Defining Away the Hazard
The Department of Energy's Solution to the High-
Level Waste Problem at INEEL

By Marvin Resnikoff and Beat Hintermann
Radioactive Waste Management Associates

On Behalf of the Snake River Alliance

June 2003

Figure 6. DOE-diagram that shows the proposed tank closure for the Performance-based Closure Alternative¹⁴⁶.

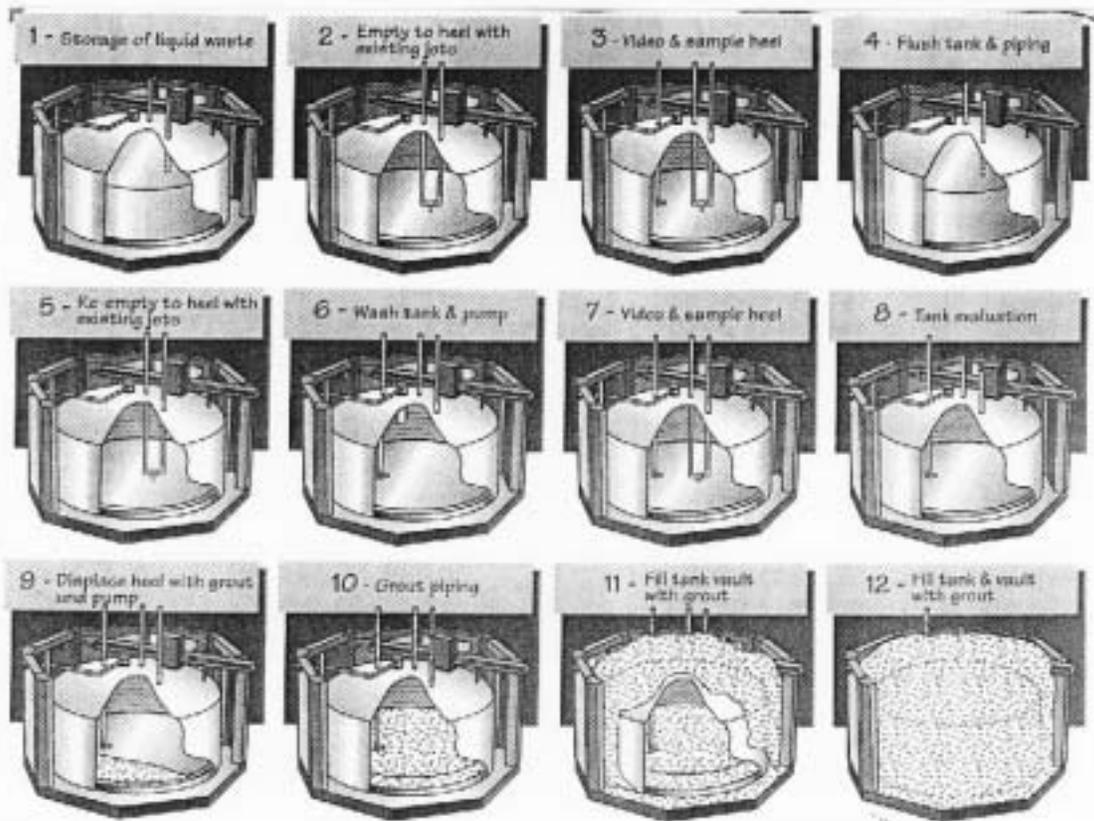
After this first disc of grout in the tank, the space between the vault and the tank, and finally the entire vault and tank are filled with grout. Fig. 6 shows a DOE diagram of the planned tank closure. The resulting monolith would be left in place forever.

After placement, the grout will be irradiated for many years. It is very difficult to foresee how it will react to such a prolonged exposure. Besides the physical integrity, the grout could also lose some of its chemical integrity. The claim of stable chemical characteristics translates into a claim of stable distribution coefficients (Kd's), because the Kd's depend on the valence state of an element, which in turn is controlled by the chemical properties of its surroundings. Thus, if the chemical properties of the grout change over time, the valence state and therefore the distribution coefficients of the waste will change as well. Also, once contaminants are leached out of the tanks, the reducing ability of the grout would have no more influence on the waste even if it persists, and the radionuclides' Kd's could change with a changing pH.

As described in the previous chapters, we question the assumptions used for the risk assessment. We are not sure that the tanks, filled with concrete and abandoned after 100 years, will remain in perfect shape for 500 years.
